Irish Air Line Pilots' Association

IALPA Safety & Technical
8th September 2022

Re: "Submission on Draft Decision on an Interim Review of the 2019 Determination (CP3/2022)"

Fig1: The Proposed Eastern Underpass Exit with elongated Pier 2, 3, 4 cul-de-sacs.

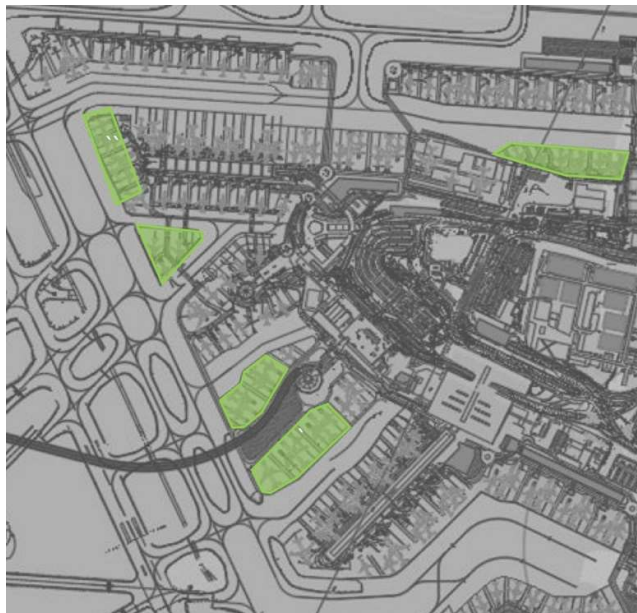
The apparent desire of the DAA to refurbish Pier 3's apron again in conjunction with the underpass, shall elongate the cul-de-sacs feeding Pier 2S, 3N&S & 4N.

Aircraft trying to access a multitude of stands have no option but to loiter on F-inner until aircraft exit and taxi onto F-Outer for a predominantly R28R departure.

When R16 is the operational runway the problem gets exacerbated starting with the conflict of Pier 3/4 cul-de-sac and aircraft vacating R16 who are allocated those parking stands.

It's obvious from Fig 1 that the DAA have grossly exceed the 12 stand limit cul-de-sacs by a wide margin. Helios shall therefore have to re simulate the traffic gridlock flows from a restrictive F-Inner and the associated elongated cul-de-sacs serving Piers 2S, 3N&S & 4N. (North/South).

For these reasons (having considered a Pier 2 replacement) we call on the DAA to pause Pier 5 / South Apron design and concentrate on advanced options by Q4 2023 for a new Pier 3 design incorporating the Underpass and APM cell.

Our Concept is for Pier 2N NBE ops with Dual NBE taxi lanes between P1S and P2N. P2S to incorporate NBE and Mars stands to an eventual Dual Foxtrot "Option 1" as outlined in PACE document i.e. CODE E – CODE C (F-outer – F-inner). This Foxtrot design to become the permanent routing for R16 operations.

Fig 2: Taxiway R designed for smooth Dual Code E operations to/from North/South Aprons!

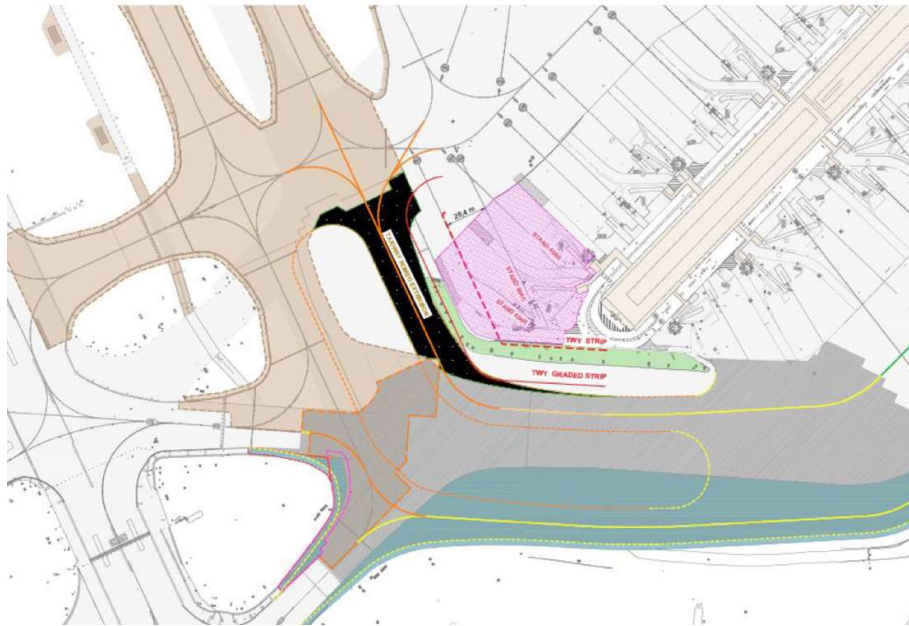
This proposed Taxiway R was supposedly designed to be safe and efficient, “ultimately mitigating bottlenecks and delays to Runway 10R and 28L and traffic accessing or egressing from the South Apron”. If constructed Taxiway R eliminates the WB aircraft 404C stand.

Presently, the WB 404C stand isn't parallel with the WB 403C stand. Therein lies the obvious conundrum, How to insert a new WB stand without breaching WTC (wing tip clearance) limits between a WB aircraft on 403C stand and a WB aircraft travelling on the propose Taxiway R and relocated Z?

Observe indicated red hatched WTC lines- a geometrically impossible pilot over centreline sweep. Were Taxiway R to be constructed we have now identified (from current drawings) a high collision risk which may have been undetected by the Airport regulator & DAA? i.e. when both WB Code E aircraft bypass each other at the head of Pier 4.

Fig 4: FCC approved LVP operations centreline taxiway B1 (in grey shaded area) to E1:

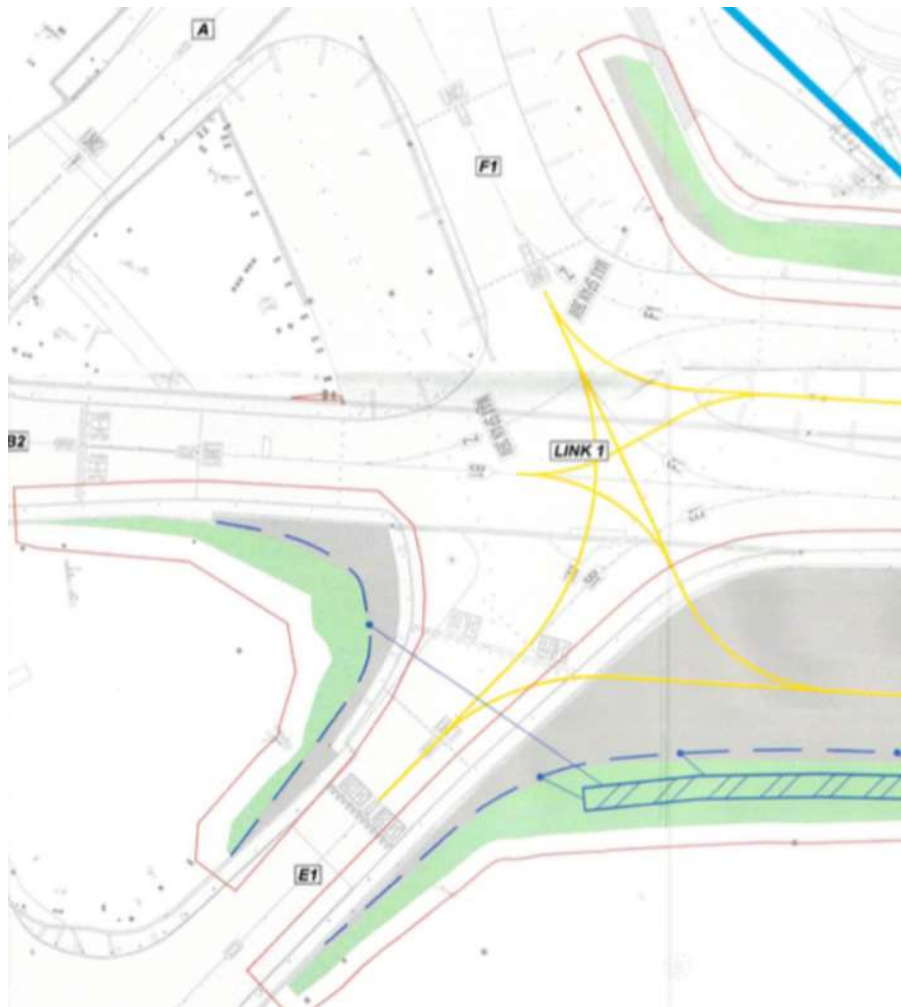
Unfortunately with the redesigned B1-E1 taxi line this critical alignment with the stop bar (shown in Fig 3 above) is impossible to replicate/execute.

- 6) FCC planners have endorsed the DAA design in Fig 4 below whereby the A330 in Fig 3 above is presumed to be able to alter its heading (Left 53 degrees) within its own footprint.

Effectively a pivotal turn on the spot.

[A turn arc between the existing CAT II, III and CAT I hold positions. Note from Fig 3 the MLG (main landing gear position was just past the CAT II, III hold.)]

Fig 5: DAA proposed 2014 Dual R28L line ups CIP 15.06.013 refused by CAR

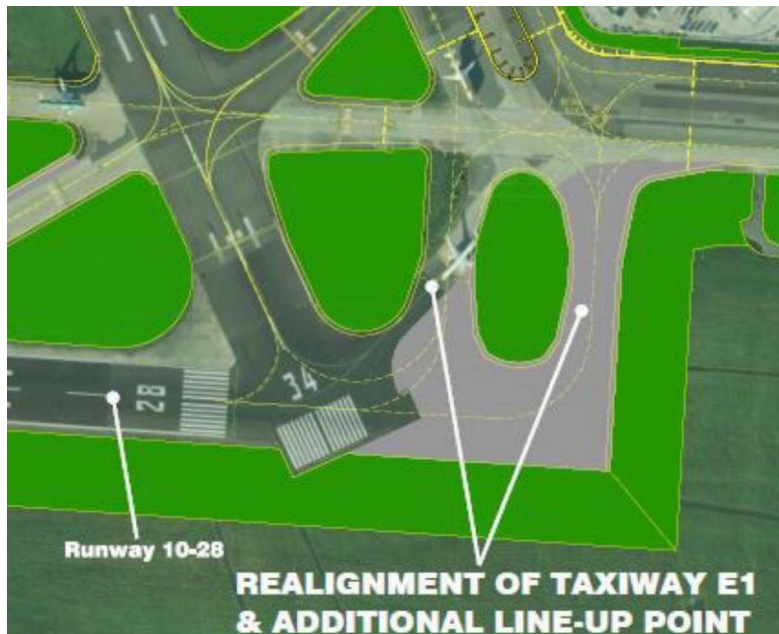
If the proposed widening of B1- Z is not permitted by SRD then we request that CAR funding be diverted for CIP 15.06.013.

CAR previously refused funding on the pretext that R28R would be the main departure Runway. But what if R28R is closed for maintenance during LVP weather conditions?

When R28L is the only available LVP departure runway the ANI needs operational departure sequencing flexibility with these two line up options. E.g. for Alternative Left/right climb out departures. (Remember R16 LVP departures are NOT an option). This typical dual layout is industry standard at International Airports, just fund it CAR!

Fig 6: EY’s 2018 Sub-optimal single sided Proposed Pier 5 expansion eliminating T2 expansion?

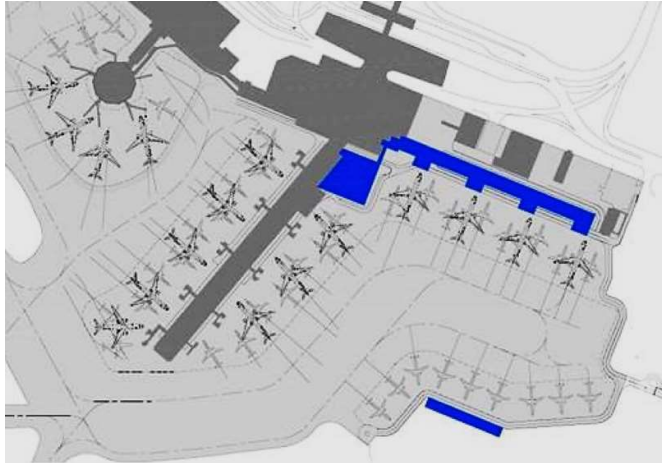
We note that the EY Pier 5 plan allegedly overcomes some of the T2 Bussing integration issues highlighted during a previous S&T presentation to CAR. However the EY footprint in Fig 6 & 7 obviously restrict T2 expansion.

Fig 8: TII latest indicative Dublin Airport Metrolink exit

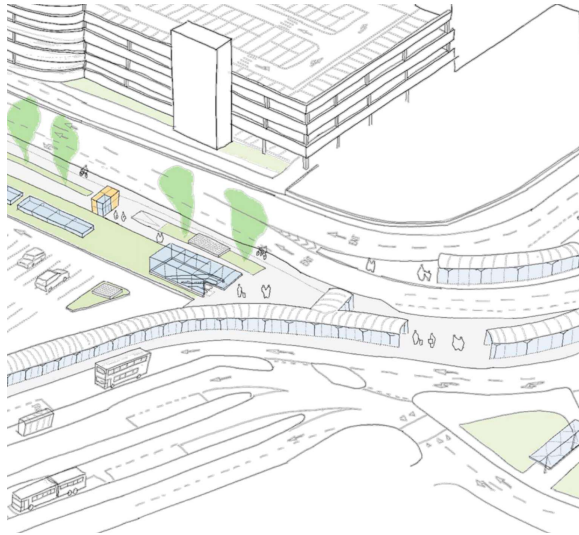
Any future DAA /Metro Development and interface issues with T1&T2 must also not impede road traffic / pedestrian free flow within the GTC (Ground Transport centre).

As can be seen below T1 passengers will constantly restrict smooth surface vehicular traffic access to the GTC.
